TECHNICAL BULLETIN

Product: VFL-900HD Viewfinder

Symptom: No operation due to blown fuse

FIGURE 1

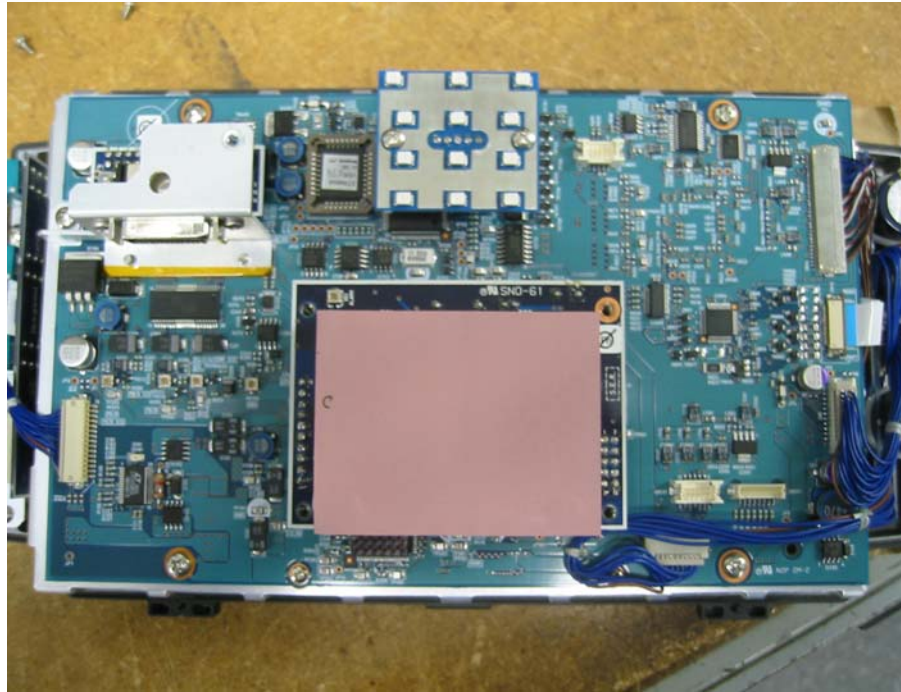
1. On the back of the viewfinder, remove the connector cover, then remove the interconnect cable.
2. Remove the 5 screws holding the rear cover in place. (2 top, 2 bottom, 1 by the connector cover.
3. Remove the power module (4 screws). This module has a red heat sink on it. Refer to Fig. 1.
4. Remove Fuse F1, located on the component side of the power module. This component is located on the left side of the board. Refer to Fig. 2
5. Replace with a 2.5A Slo Blo fuse.
6. Reinstall the power module, rear cover, interconnect cable, and connector cover.

When the viewfinder is turned on, the surge current may be high enough to cause the fast-acting fuse, F1, to open. To correct this problem, it is recommended to change F1 to a Slo Blo type fuse.
